UNITED STATES
NUCLEAR REGULATORY COMMISSION
WASHINGTON, D.C. 20555-0001

SUBJECT: PEACH BOTTOM ATOMIC POWER STATION, UNITS 2 AND 3 - ISSUANCE
OF AMENDMENTS RE: MAXIMUM EXTENDED LOAD LINE LIMIT ANALYSIS
PLUS (CAC NOS. MF4760 AND MF4761)

Amendment No. 305
Renewed License No. DPR-44

Figure 3.1-1 - MELLLA+ Operating Domain for PBAPS

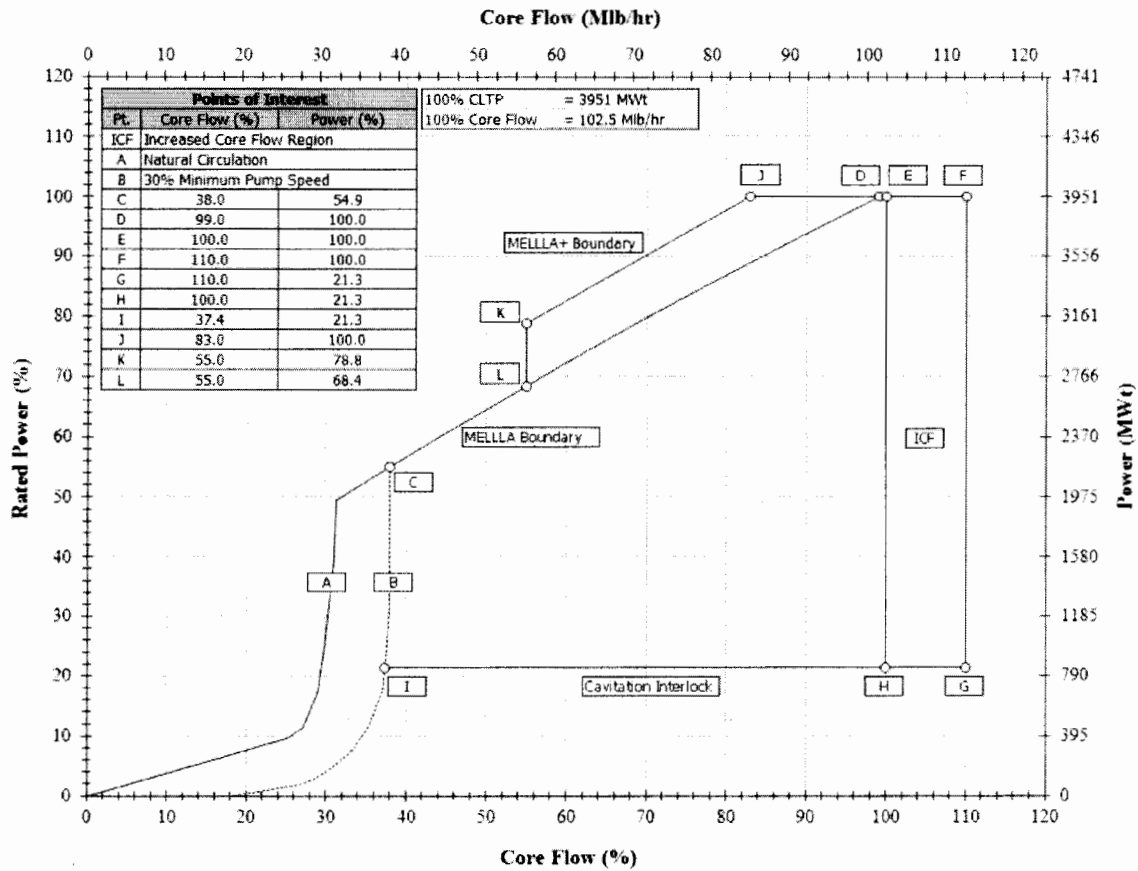
As discussed in SAR Section 2.2.1, as required by the M+ LTR Limitation and Condition 12.6, the SLMCPR is calculated at Statepoints E, J, K, and F (shown in Figure 3.1-1 of this SE). In addition, uncertainties for SLO are applied to Statepoints J and K. The calculated values will be documented in the SRLR.

At the MELLLA+ low corner (Point K of Figure 3.1-1), the power-to-flow ratio is maximized and there is the potential to encounter void formation in the bypass region. The NRC staff requested that the licensee determine the effect of bypass void formation on local power range monitors (LPRMs) and traversing incore probes (TIPs). The licensee's evaluation concluded that no bypass voiding is expected at the highest TIP elevation that corresponds to the highest LPRM detector elevation. This value is calculated using the ISCOR hot channel methodology, which is conservative, because it neglects cross flow between bundles in the bypass region.

- 12.23.5 – The PBAPS power density at the full power-minimum flow statepoint in the MELLLA+ operating domain (Point J of Figure 3.1-1) is 46.4 MWt/Mlbm/hr, which does not exceed the 52.5 MWt/Mlbm/hr limit.

The power-flow map (SAR Figure 1-1) shows Point F with 110% flow in the increased core flow (ICF) region. What is the maximum core flow that PBAPS can achieve? Is this a function of exposure (e.g., bottom-peaked shapes may result in reduced max achievable flow)? Is PBAPS susceptible to bi-stable flow in the recirculation loops? If so, what is the maximum (or range of) achievable recirculation flow used in normal operation to minimize bi-stable flow concerns?

Figure A-1 - Illustration of SLMCPR adders

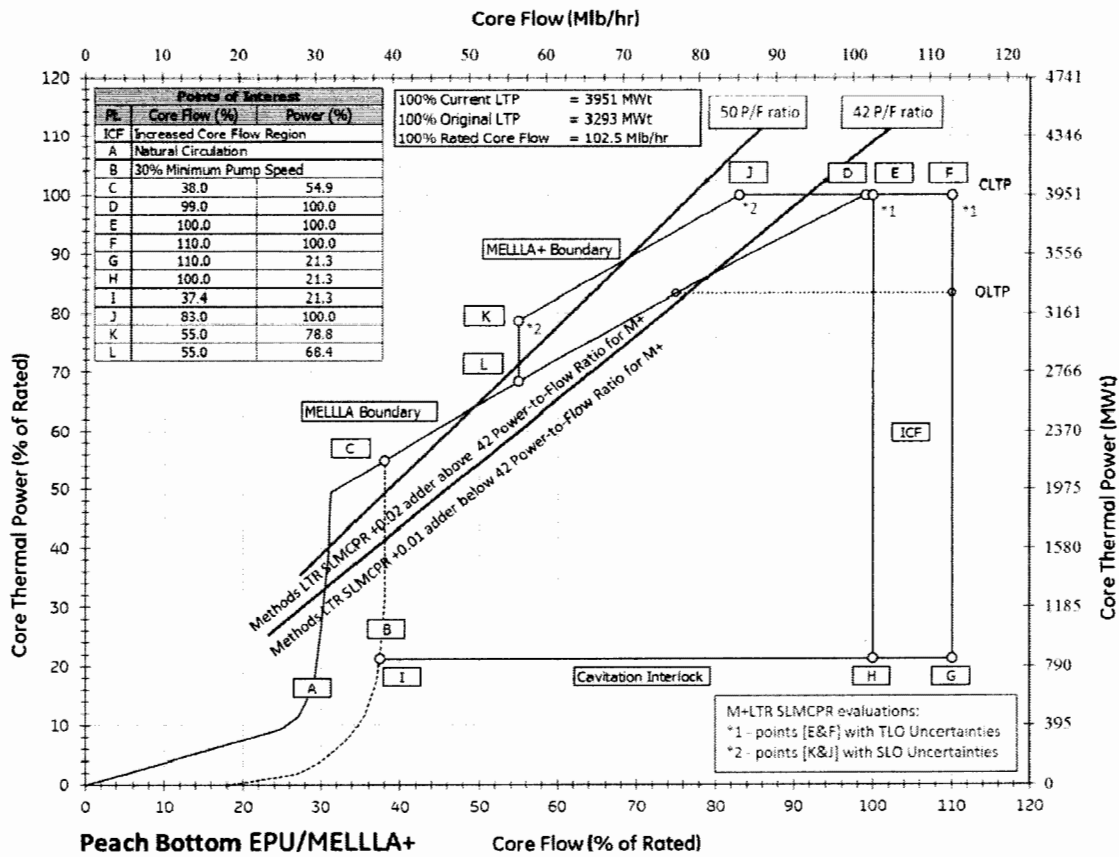
The licensee provided an illustration of the SLMCPR adder used as show in Figure A-1. For points J and K, which lie inside the MELLLA+ region, single loop operation (SLO) uncertainties are used. For Points F, E, D, and L, two loop operation (TLO) uncertainties are used. For all points, the Methods +0.02 adder is used conservatively, even though a value of +0.01 could have been used for points F, E, and D because they lie under the 42 MWt/Mlbm/hr line.

Conservative application of the +0.02 adder is acceptable because it will establish the most limiting SMCPR values in the Technical Specifications. This RAI is closed.

Table A-2 - TTWBP-ATWSI Sensitivities PCT Results

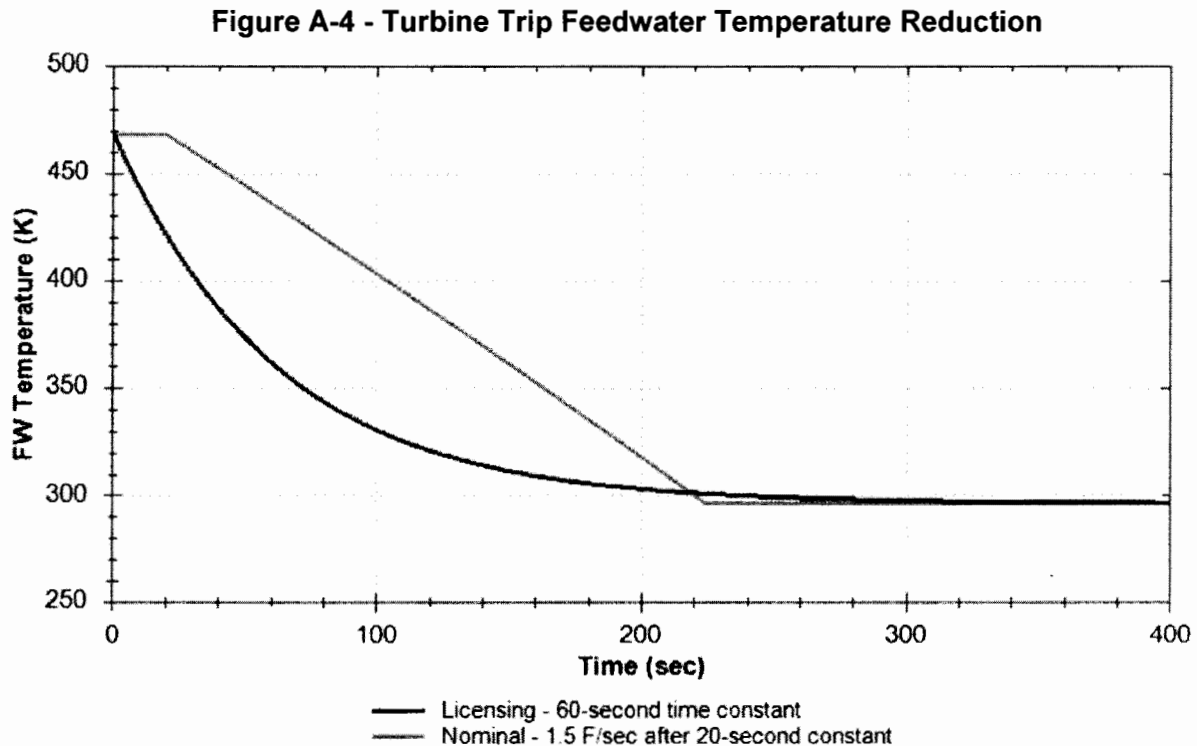
1. Feedwater cooling rate. Two cooling rates were used for the analysis:
 - a. A licensing case, where a 60 second exponential time constant is used to reduce feedwater temperature from nominal to condenser temperature.
 - b. A nominal case based on training simulator modeling where the cooling rate of 1.5°F/second is assumed following 20 seconds of the temperature remaining constant, which results in a slower cooling rate (see Figure A-4).
2. Operator action timing:
 - a. 90 seconds, 120 seconds, and 200 seconds to initiate feedwater flow reduction.
3. Hot rod peaking factor:

- a. [[]], corresponding to 95 percent of the operating limit.
 - b. [[]], corresponding to the actual PBAPS peaking factor at the exposure analyzed.
4. Tmin model. Two models were used:
- a. Modified Shumway Correlation.
 - b. THN, which is significantly more conservative.

The licensee provided the requested sensitivity calculations. Tables 1 and 2 of the RAI response (reproduced here, in part, as Tables A-2 and A-3) summarize the PCT results of TTWBP-ATWSI sensitivity calculations.
